CITY OF ALBUQUERQUE

Re: Murphy's Express, 2707 Carlisle Blvd. NE,

Request for Permanent C.O. –Accepted

Re: Murphy Express – 2707 Carlisle Blvd NE – Grading and Drainage Certification

Disk File.

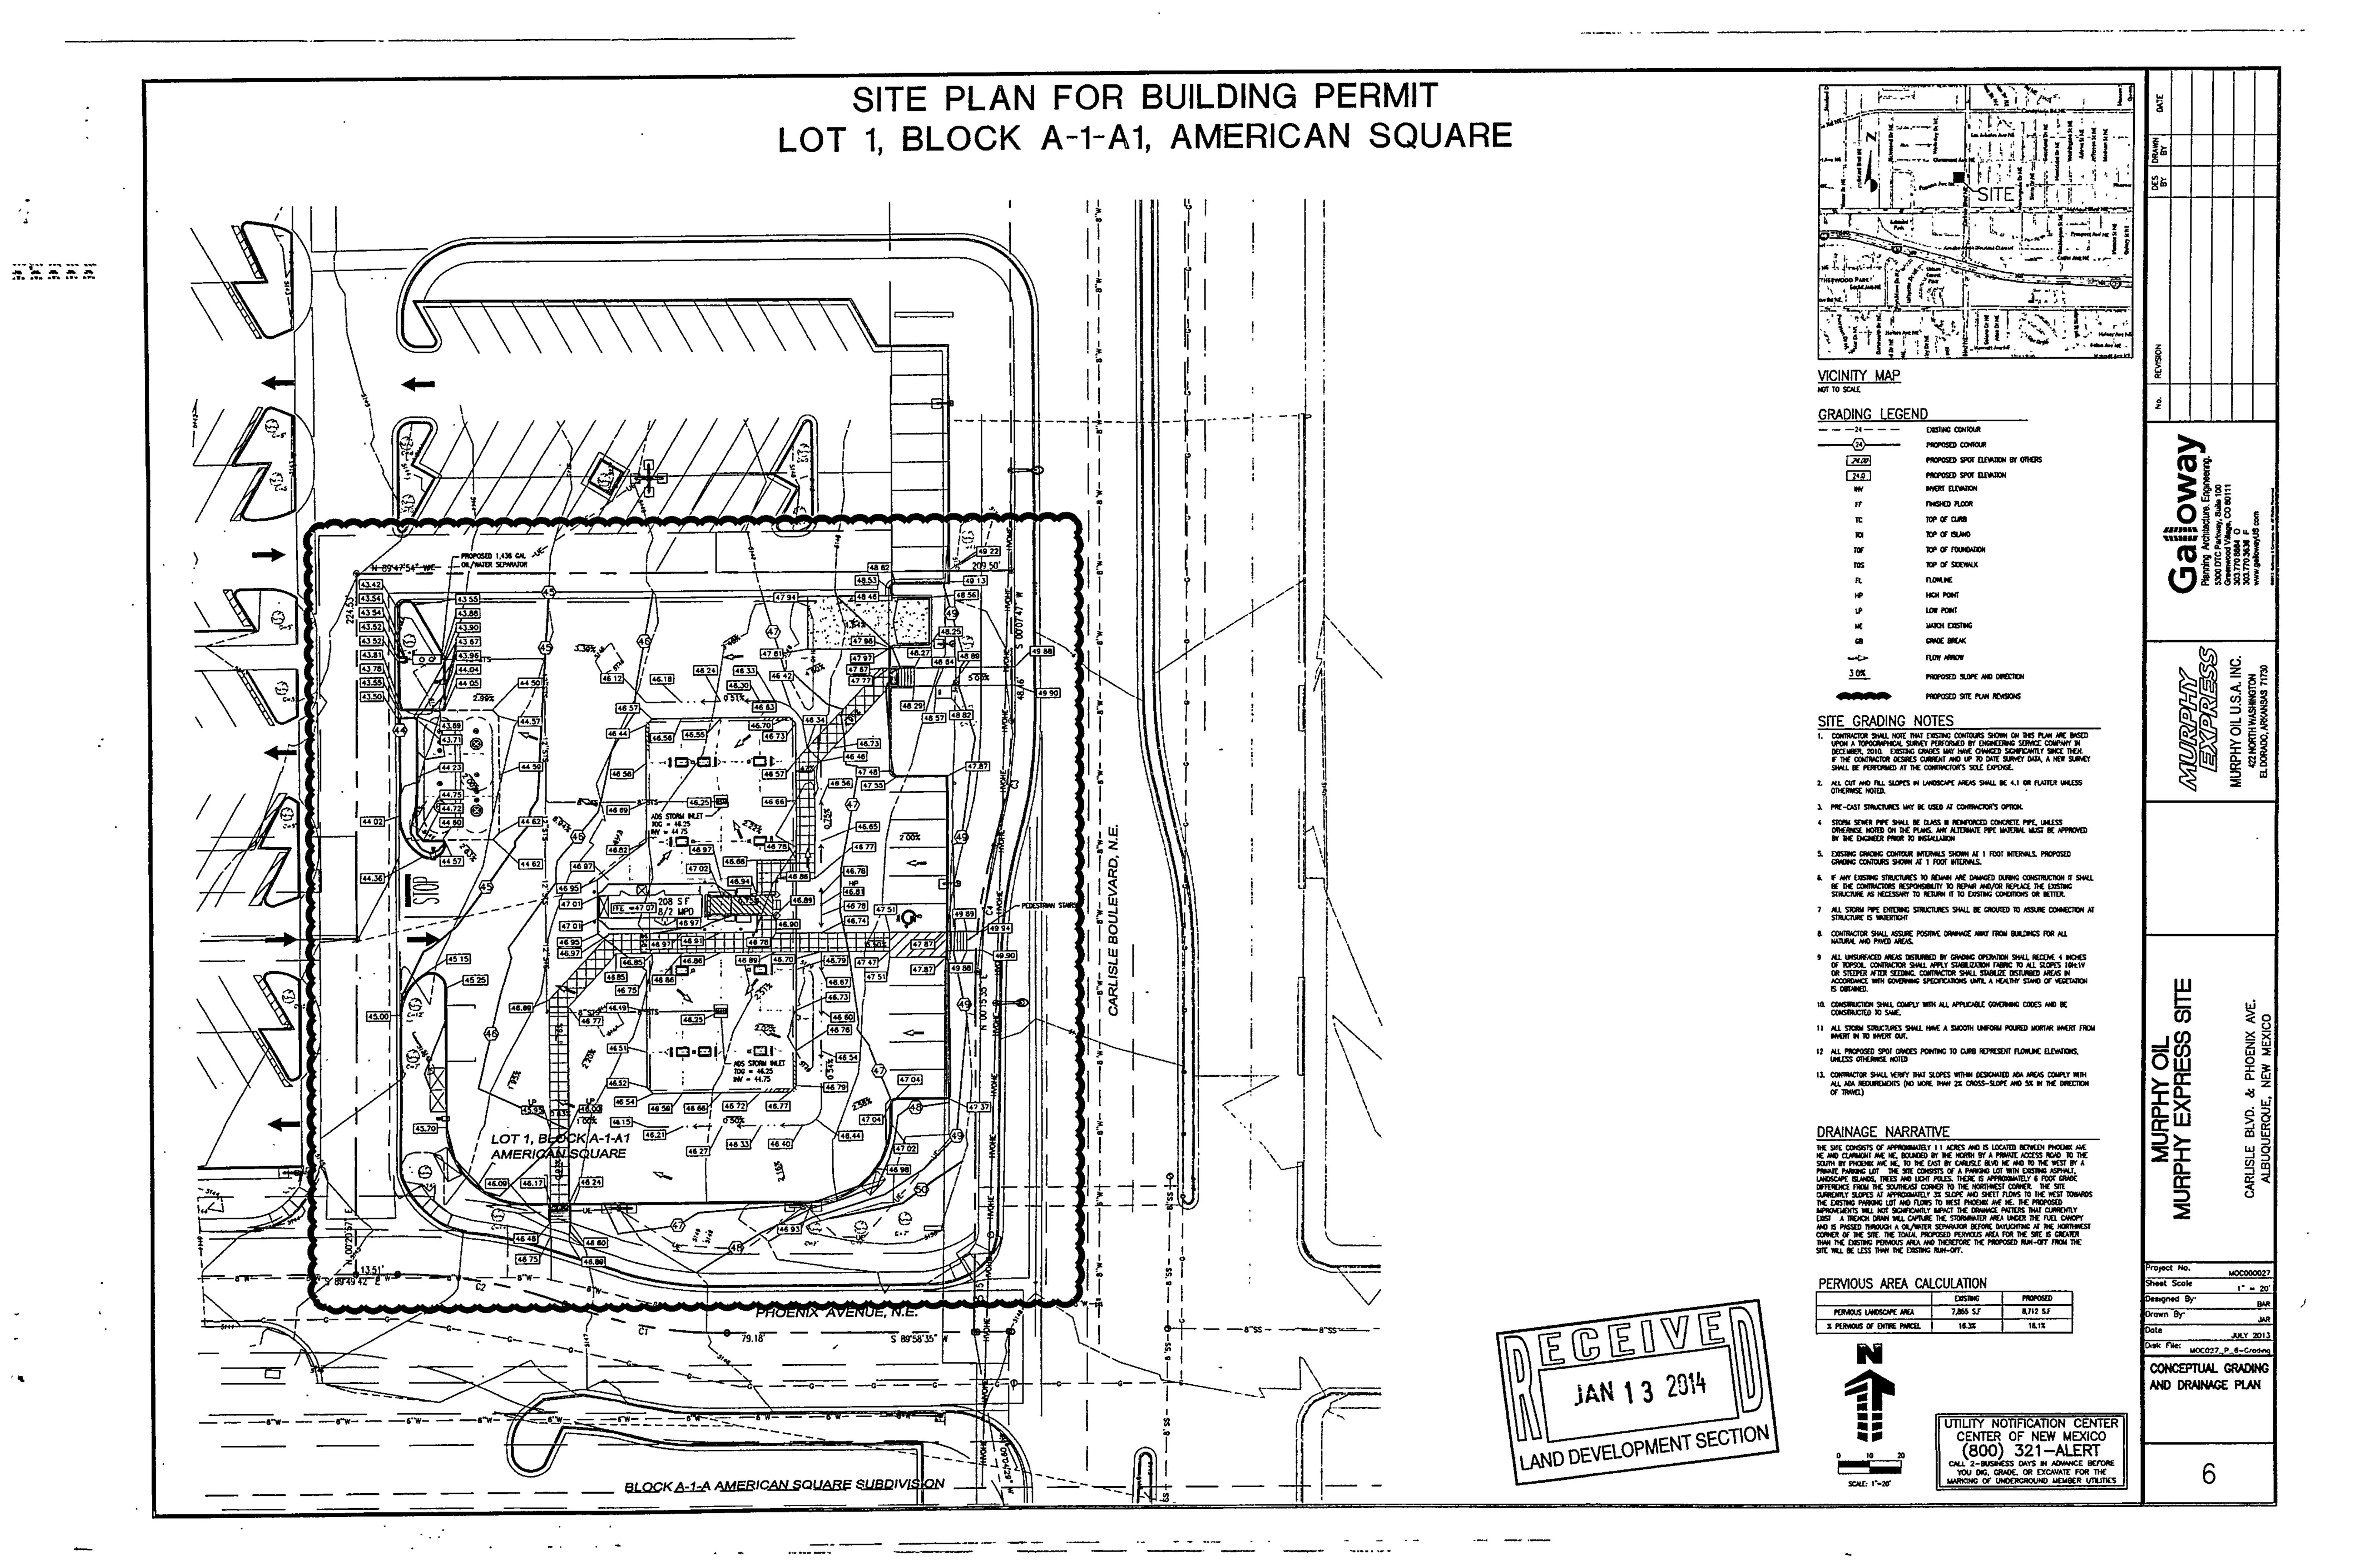
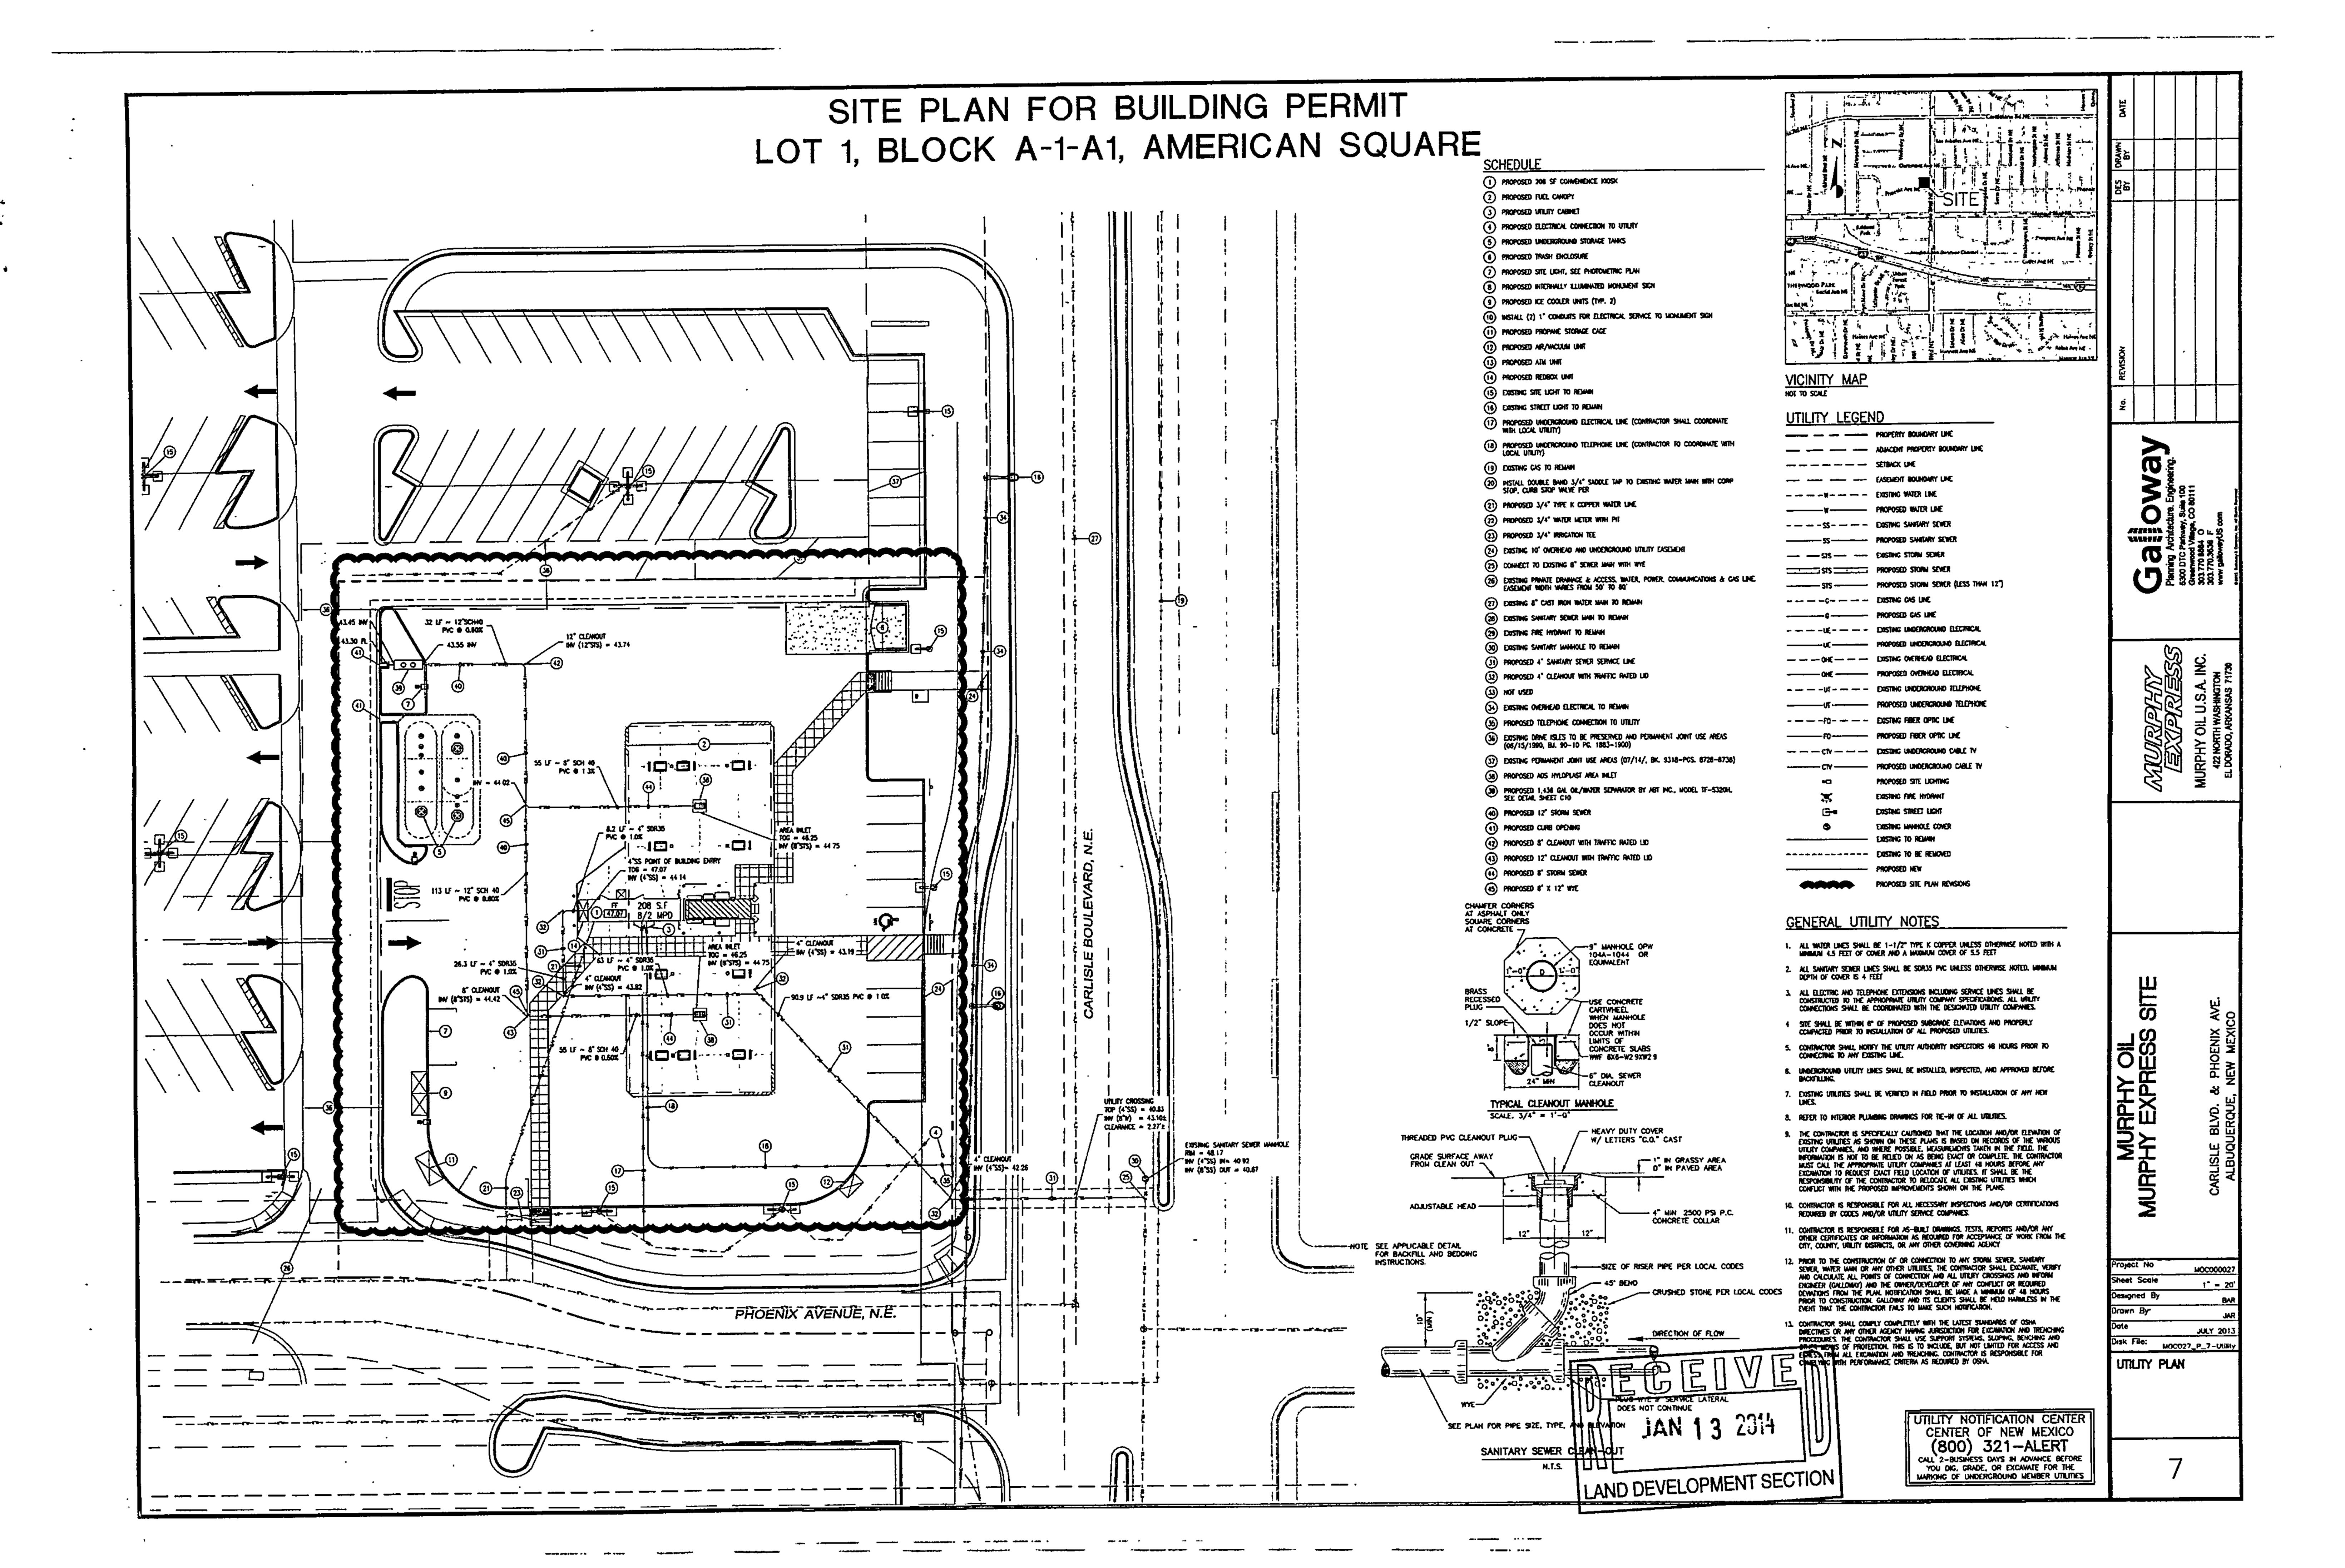
It appears that we've run into an issue with the coolers and sales racks being proposed in front of the cashier window. They are a lot larger than we had anticipated. The largest cooler is 3'-7 1/2"W x 9'-7"L. As a result, it will encroach into the 6' wide walkway that we have constructed on the south side of the kiosk.

I have a two part question. First, this project went through EPC and DRB and the comments that came back in regards to accessible pathways were that we needed a 6' accessible path from Carlisle to the building and a 6' wide accessible path from the ADA parking to the building. It seems to me that we are meeting both of those criteria even without the walk that is being encroached upon south of the building. This path leads to a private side walk on the south side of the property. I took this project over toward the end of the DRB approval process, so I don't know why the walk to the south side of the property was added in the first place. It seems to be in excess of what the DRB comments recommended, so I wanted to know if it is even needed?

The second part to my question, is, if this walk is required by the City, does it need to be 6' in width? Looking through the TCL criteria, it appears that the city standard accessible walkway width is 4' instead of 6'.

I have attached a sketch of what we would like to propose as a fix and I've also attached the DRB comments that we received. Please give me a call to discuss when you get a chance. At this point, I'm trying to figure out what options we have and since we are trying to wrap these projects up as soon as possible, time is of the essence.
